FORT WAYNE COMMUNITY SCHOOLS 2025 GENERAL BUILDING SYSTEMS 2 (GBS2) – FOREST PARK, FRANKE PARK,

Addendum No. 01

February 10, 2025

Project No. 24047

ATTACHMENT 06
Drawing FO-01

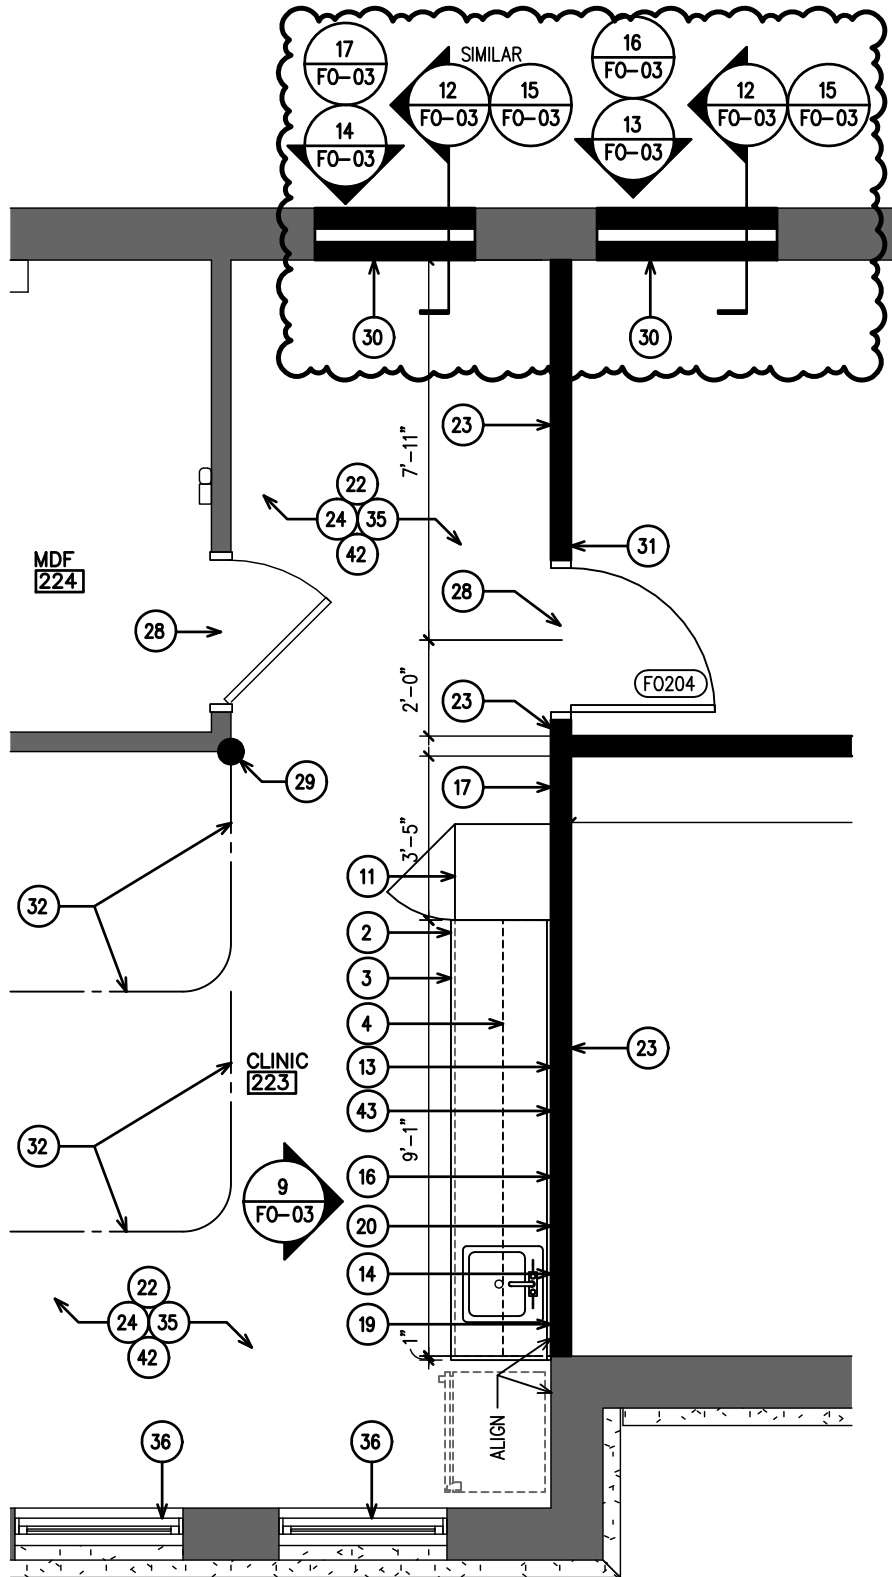
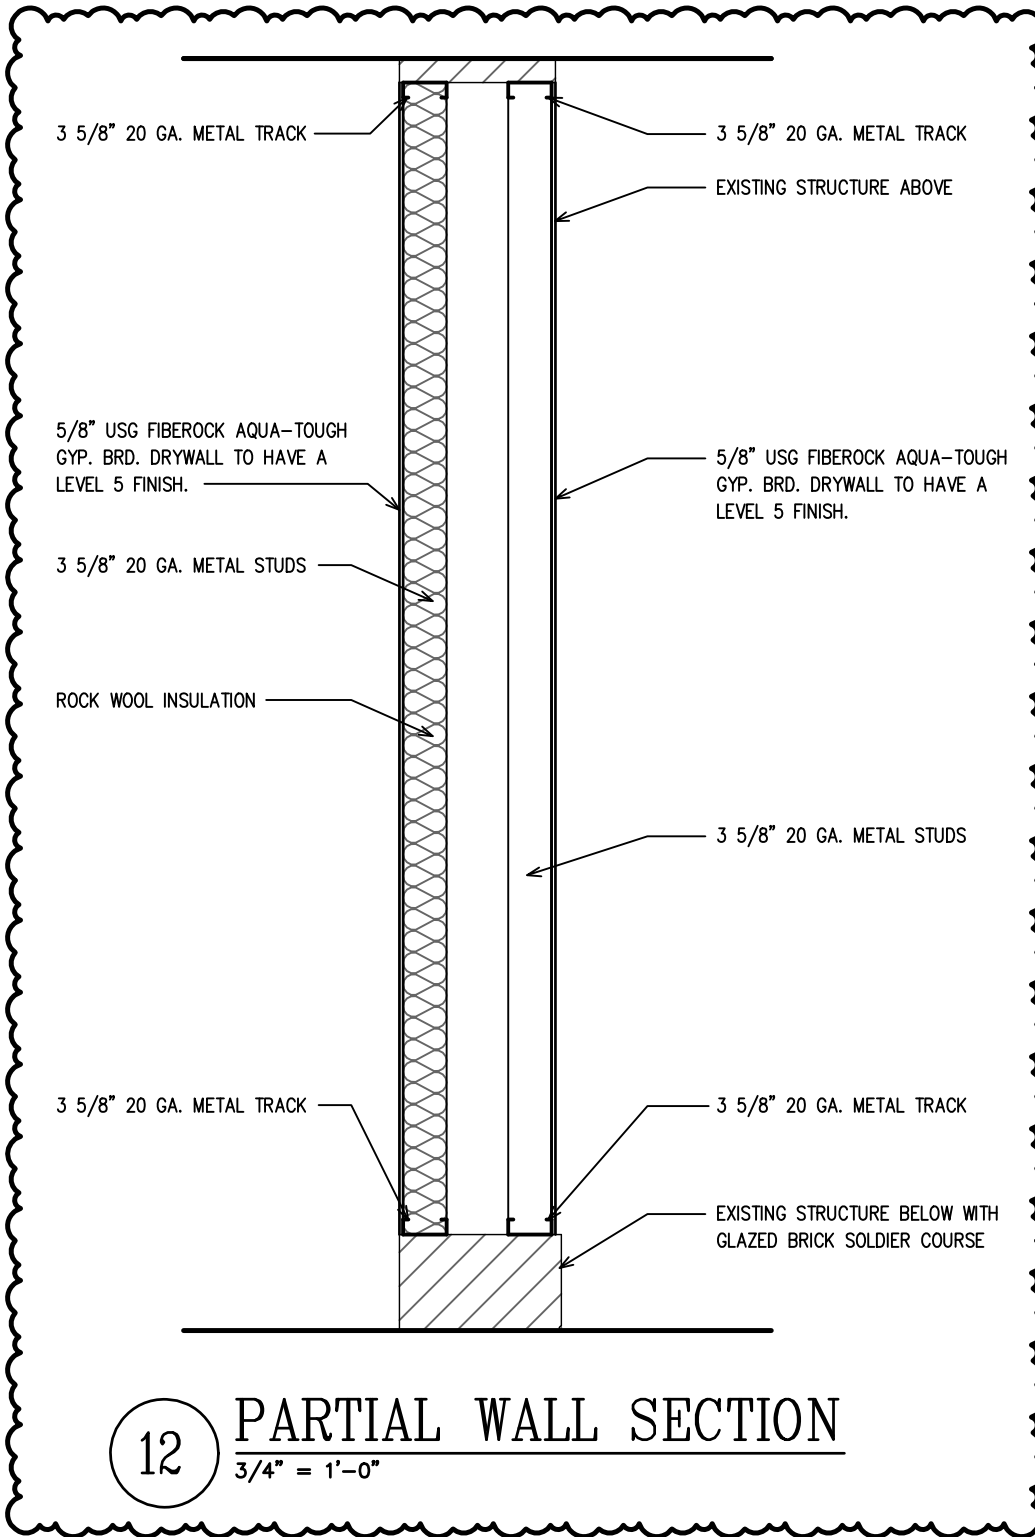
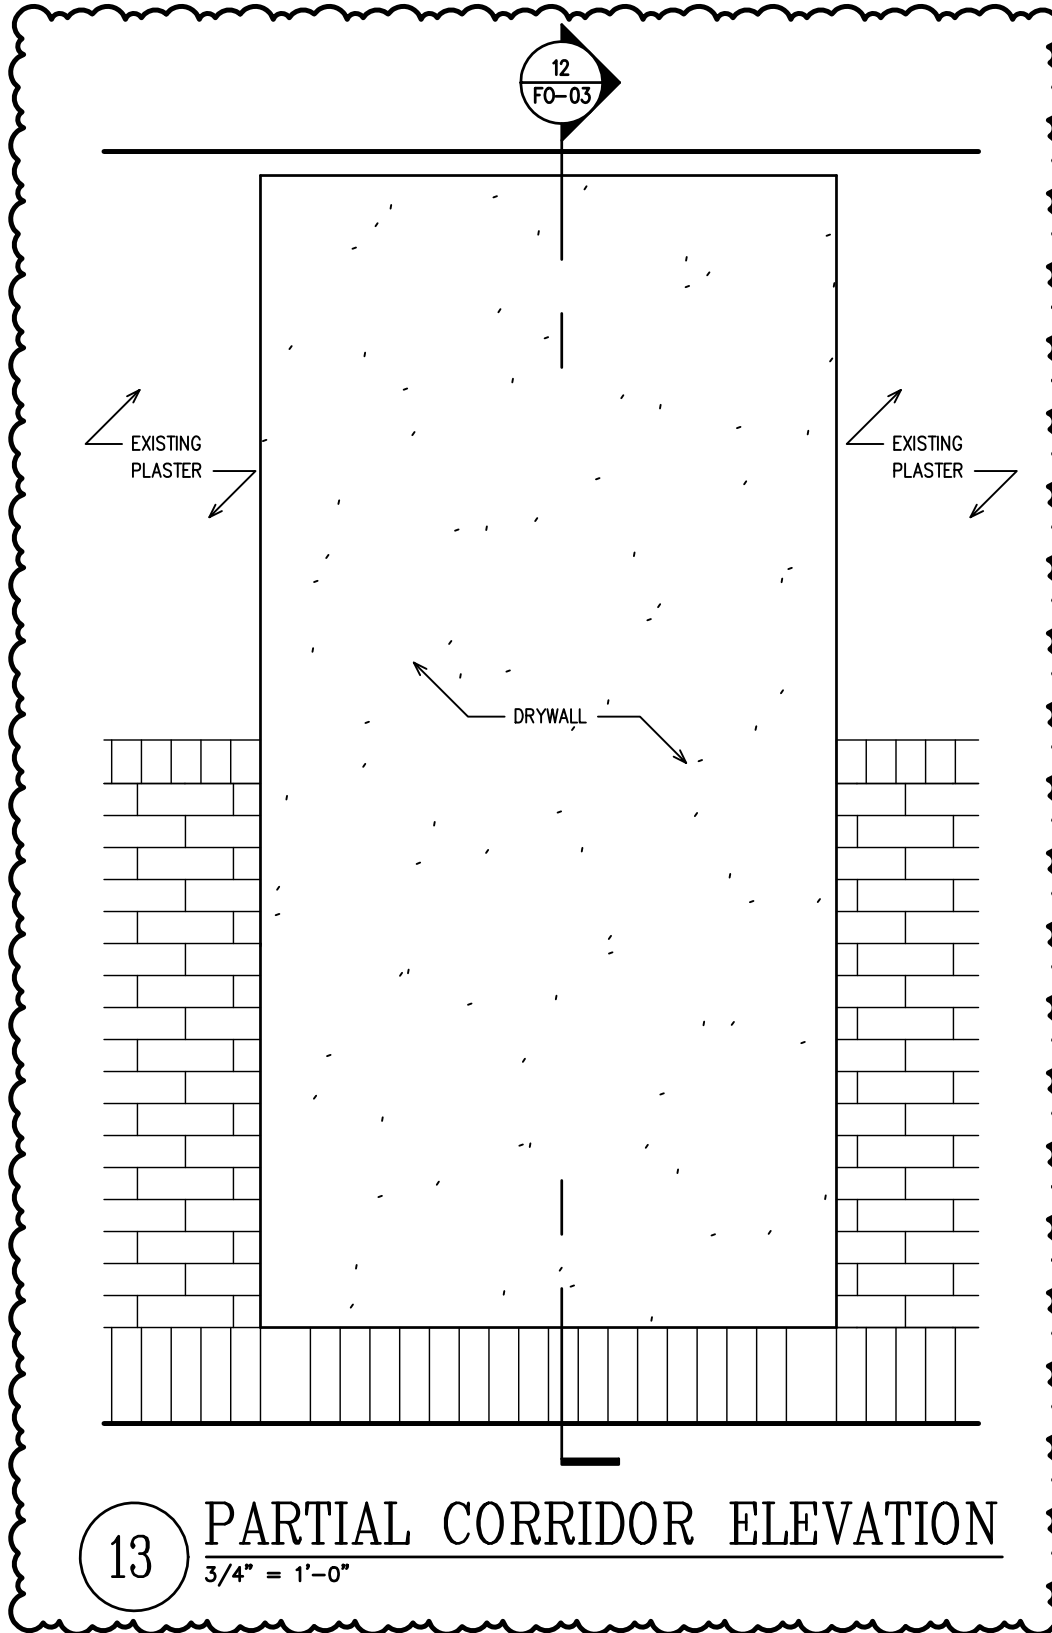
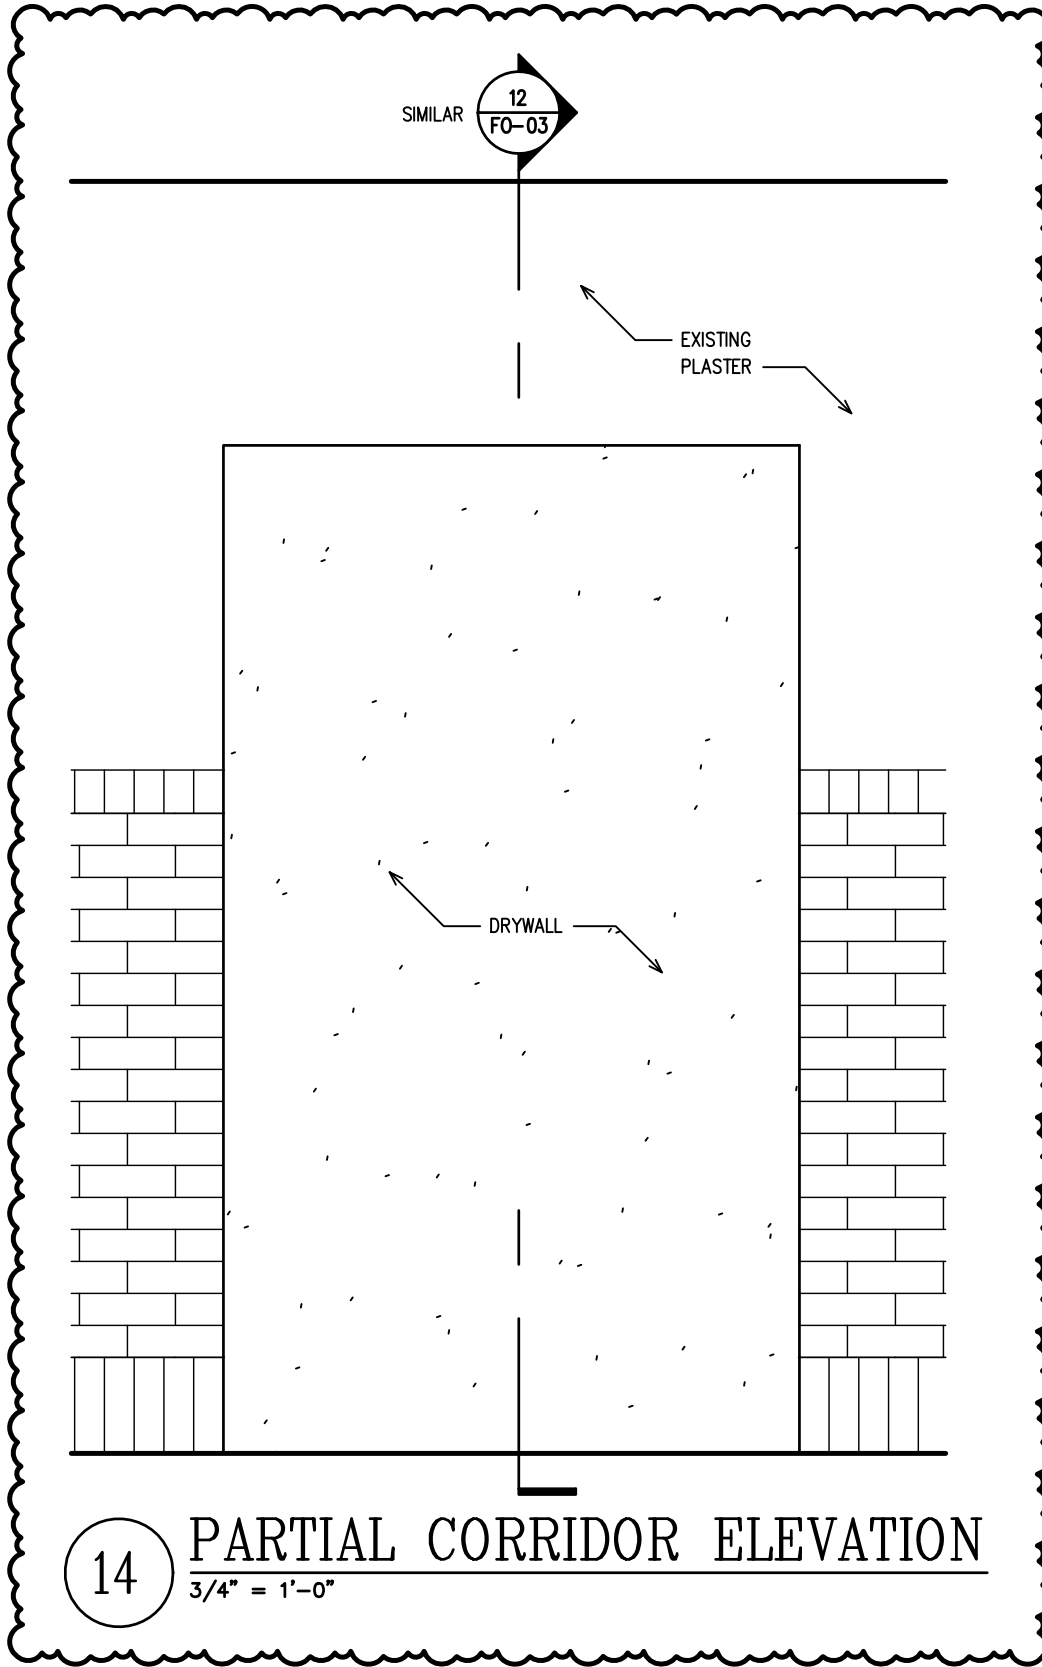
3. Detail 1 – Enlarged First Floor Office Plans – Architectural Plan: Make the following changes and/or corrections:
 - a. Remove note tag 33 from Clinic Toilet 223A

- b. Add tags and arrows as shown. **See Attachment 06.**
- c. **Sheet FO-02:**
 1. Detail 1 – Enlarged First Floor Office Plans – Architectural Plan: Make the following changes and/or corrections:
